PZ&B Staff Combination Memorandum: Landmarks Preservation Commission and Town Council

SUBJECT: COA-23-043 (ZON-23-117) 235 BANYAN RD (COMBO)

MEETING: MAY 22, 2024, LPC
JUNE 12, 2024, TC

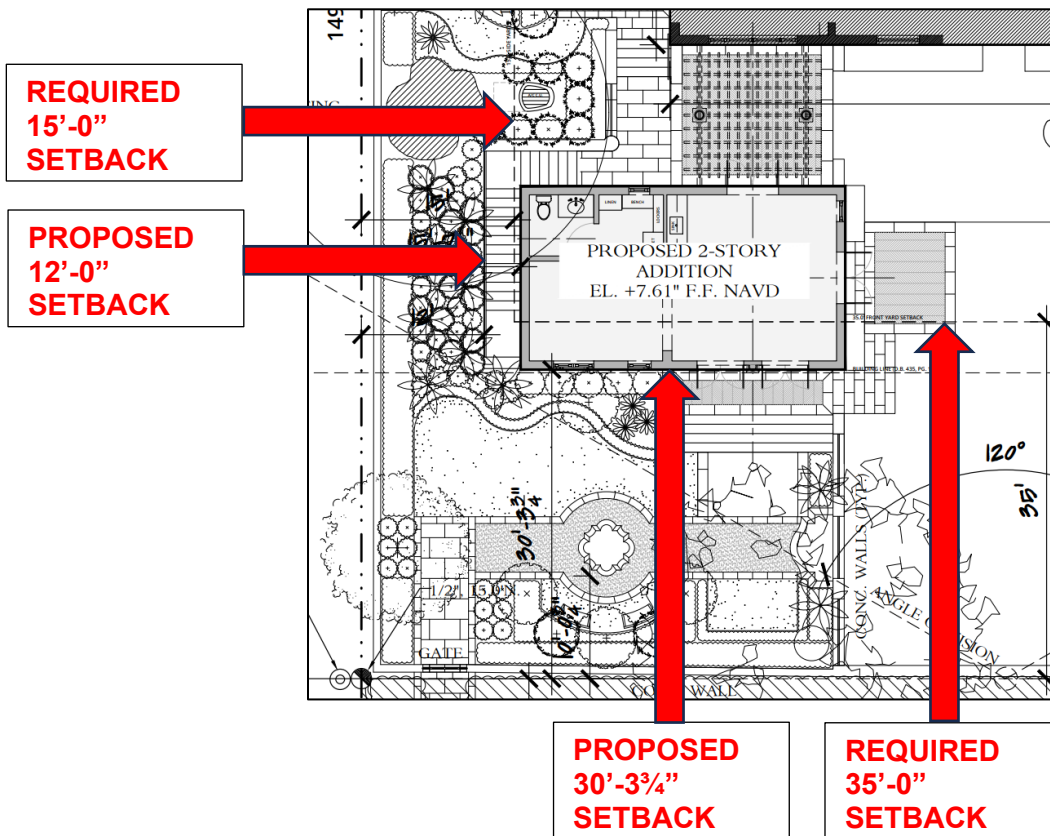
- **VARIANCE #1:** Decrease of the front yard setback of 30'-3¾" in lieu of the required 35'.
- **VARIANCE #2:** Increase of the building height plane requirement.
- **VARIANCE #3:** Decrease of the side yard setback of 12'-0" in lieu of the required 15'.

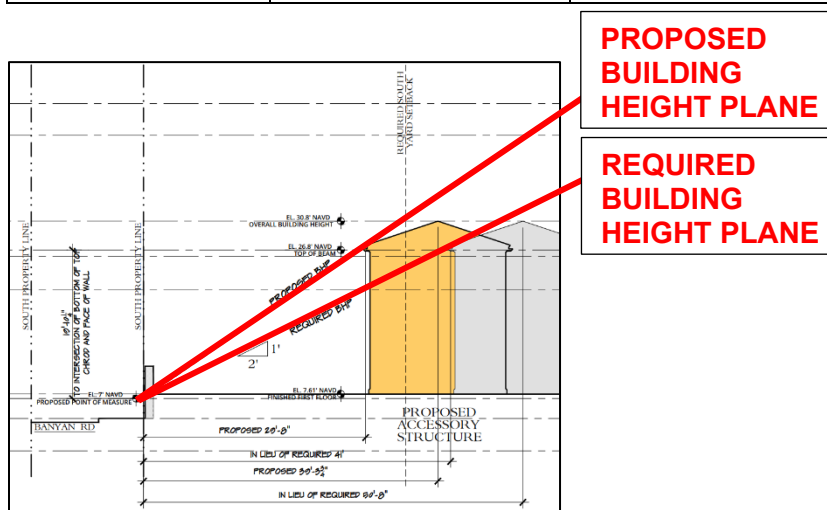
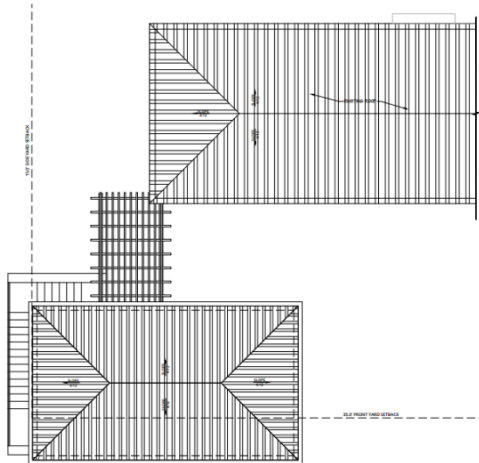
As the diagram below illustrates, **Variance 2** occurs where a southern portion of the addition's roof intersects with the building height plane.

Code Section	Required	Proposed	Variance
Variance 2: Sec. 134-843(a)(7):	Building Height Plane of 41'-0"	Building Height Plane of 29'-8"	11'-4" <i>ADDITION ROOF</i>

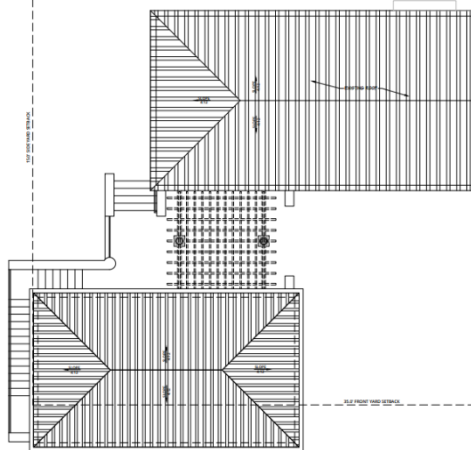
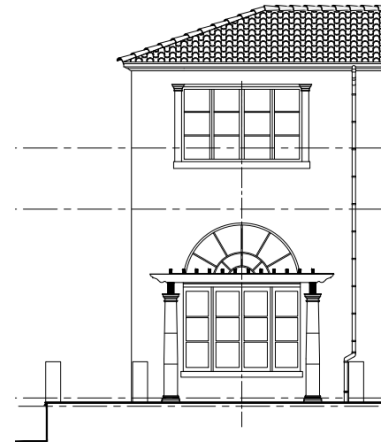
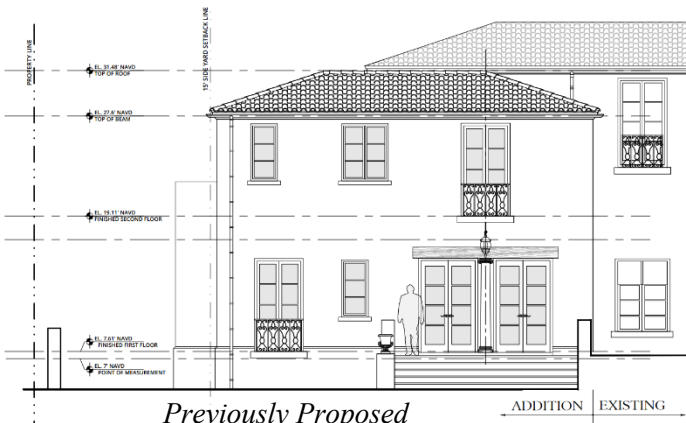
The revised design alters the location of the trellis and columns on the north side of the addition:

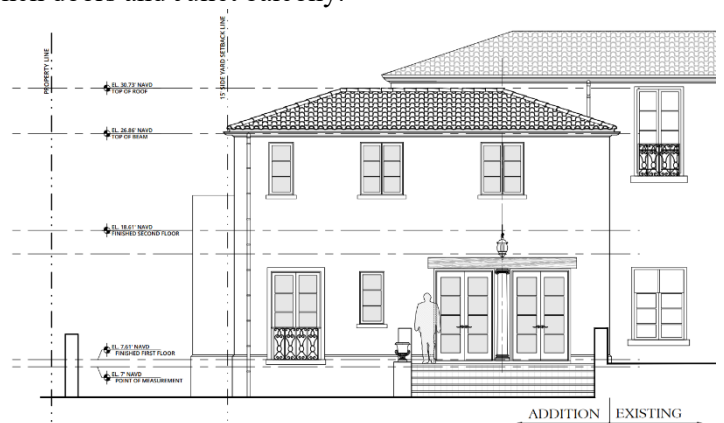
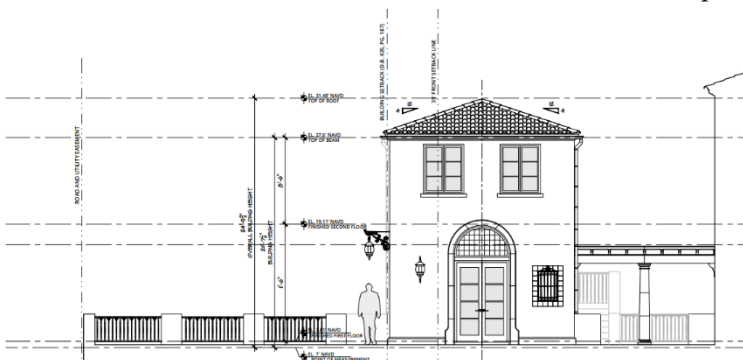
The building height and overall building height was reduced by 9". On the south elevation, the size and scale of the windows and doors was reduced. A pair of casement windows is proposed on the second floor in lieu of the previously proposed French doors and Juliet balcony.

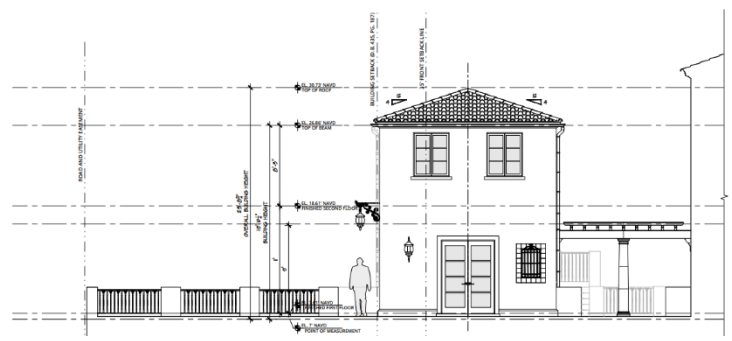
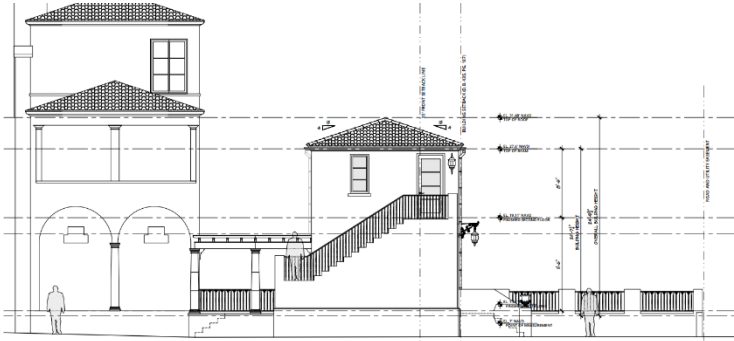
On the east elevation, the size and scale of the windows was reduced. In addition, the arched stone trim and decorative tile were removed and replaced with a stucco band.

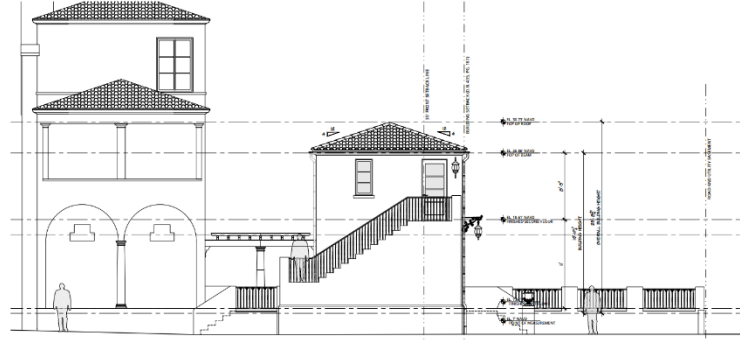
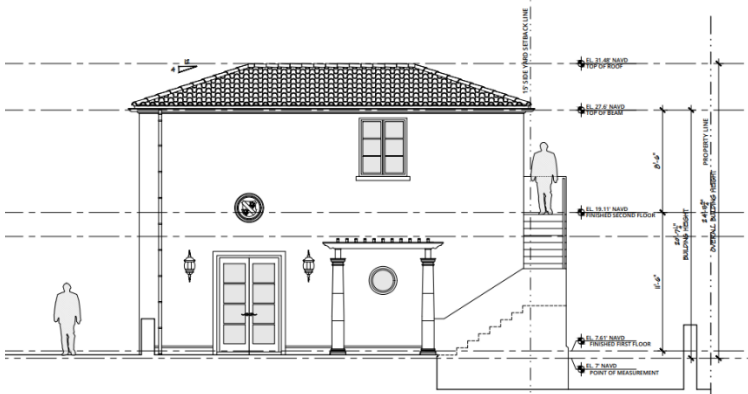
On the west elevation, the size and scale of the window was reduced. Also, the door height was reduced.

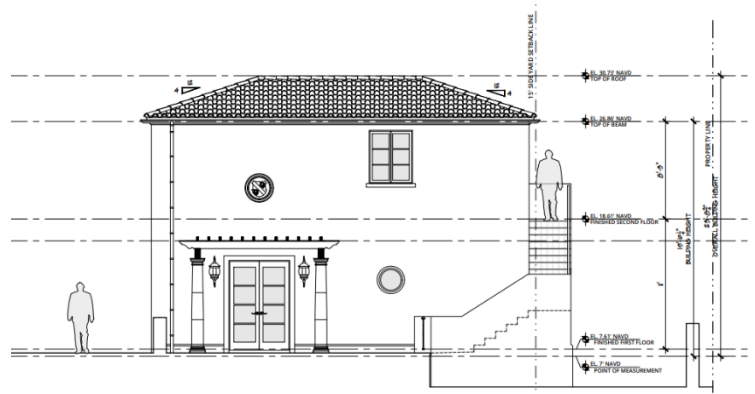
On the north elevation, the size and scale of the window was reduced. In addition, the proposed trellis was relocated to align with an existing window on the residence and a new door on the addition.
